**Re: Wyncote Sub-Station Land Development Application**

**Re: Staff Review Comments of LD-19-01 for the property located at 357 Highland Avenue, Jenkintown, Pa. 19046. Wyncote Substation Property.**

**SUBJECT: WYNCOTE SUB-STATION PARKING PLAN – AT SWITCHVILLE CROSSING  
PRELIMINARY LAND DEVELOPMENT REVIEW NO. 2  
ABINGTON TOWNSHIP, MONTGOMERY COUNTY, PENNSYLVANIA  
PROJECT NO. 1926004R**

Re: MCPC #19-0038-001  
Plan Name: Wyncote Substation  
(744 s.f. on 0.62 Acres)  
Situate: Southeast Corner of Highland & Kenmore Avenues  
Abington Township

Applicant's Plan

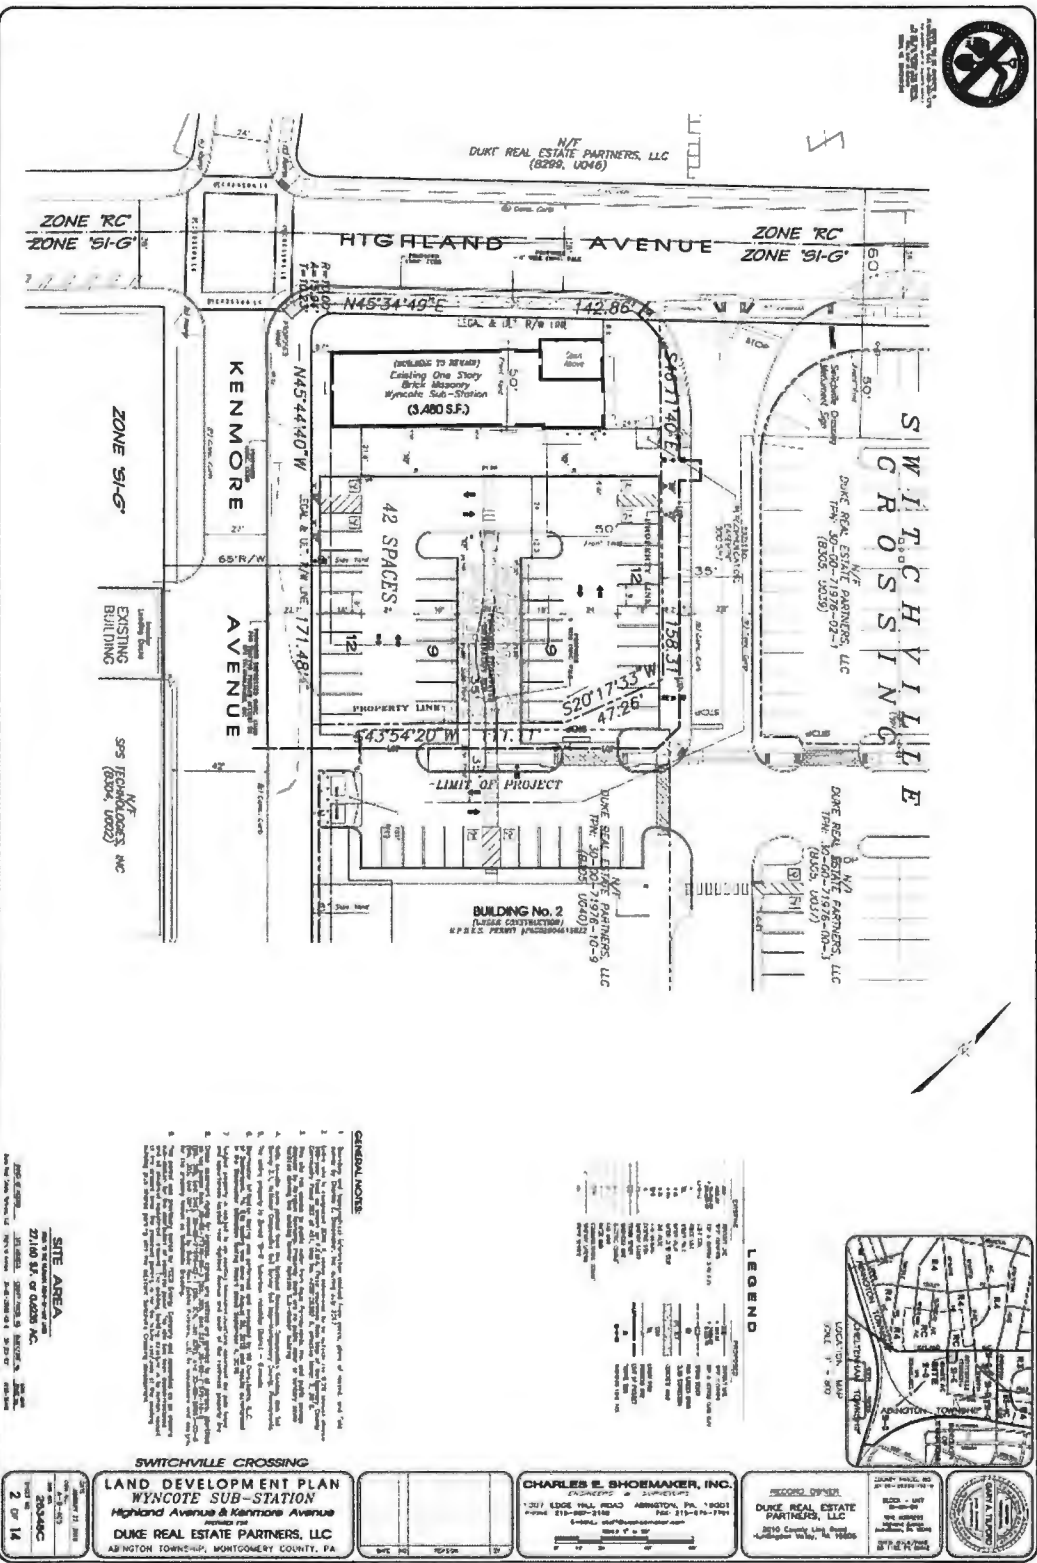
- A. Crosswalks [§146-29.D]. The addition of four crosswalks to the intersection of Highland and Kenmore will be a welcome improvement for pedestrian safety. We recommend the design be highly-visible, such as ladder, continental or zebra styles (“continental” style crosswalks are proposed within the parking area).
- B. Sidewalk. Does the absence of proposed sidewalk on Kenmore Avenue meet the Township’s future pedestrian goals? [§146-27]. The plan does not provide sidewalk along the project site’s side of Kenmore Avenue. In staff meetings with the applicant, the applicant explained that sidewalk was not included in that location, in part due to the need to reserve room for a truck backing area (note proposed area of depressed curb). The applicant also proposes

an earthen berm in this area, although it is not required. However, the distance from the depressed curb to the parking area is 22.7 feet, so there may well be room for a sidewalk and verge [§2504.E]. Such a sidewalk could be connected to the sidewalk and crosswalk network on the interior of the Switchville Crossing development.
